| Document Title: | SOUTH COAST AIR QUALITY MANAGEMENT DISTRICT TURBINE UPGRADE ENGINEERING EVALUATION AND PROPOSED FACILITY PERMIT |

| SOUTH COAST AIR QUALITY MANAGEMENT DISTRICT ENGINEERING AND PERMITTING APPLICATION PROCESSING AND CALCULATIONS | PAGES 294 | PAGE 1 |

EVALUATION FOR PERMITS TO CONSTRUCT FOR MODIFICATION OF TURBINES TO ADD SIEMENS A+ TURBINE UPGRADE & INCREASE OPERATING SCHEDULE

Figure 1
Additional Receptors and Flagpole Receptor Locations

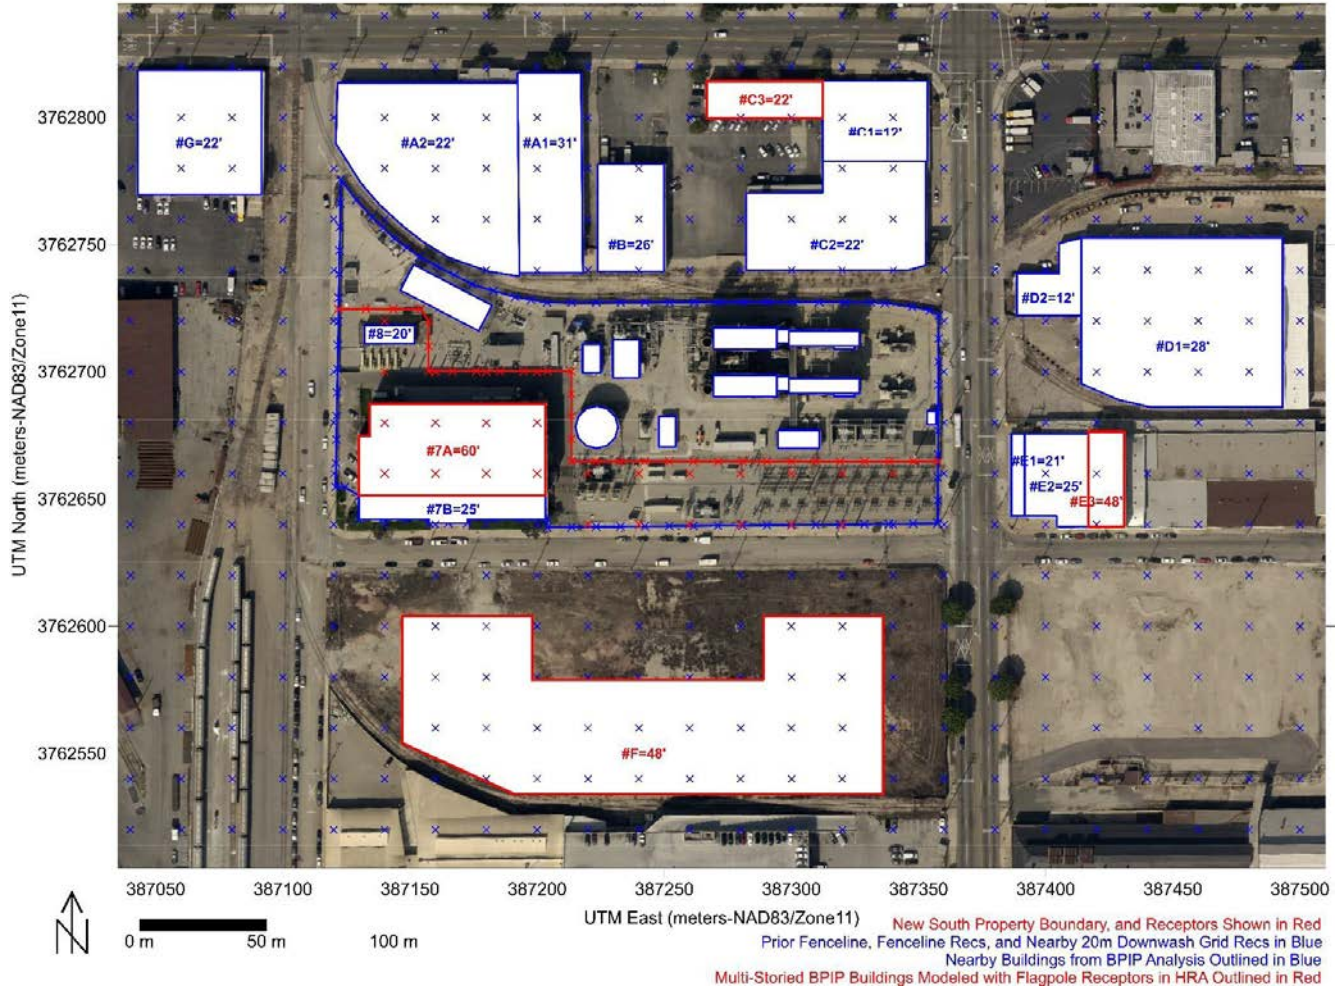
A review of all the properties surrounding the project site with Google Earth street view show mostly single-story warehouses and other commercial properties. Therefore, flagpole receptors are not required for most nearby properties. Any nearby multi-storied structures are identified on the attached Figure 1 and were modeled with flagpole receptors at the appropriate heights to update estimates of off-site worker exposures. These structures are listed in Table 1.
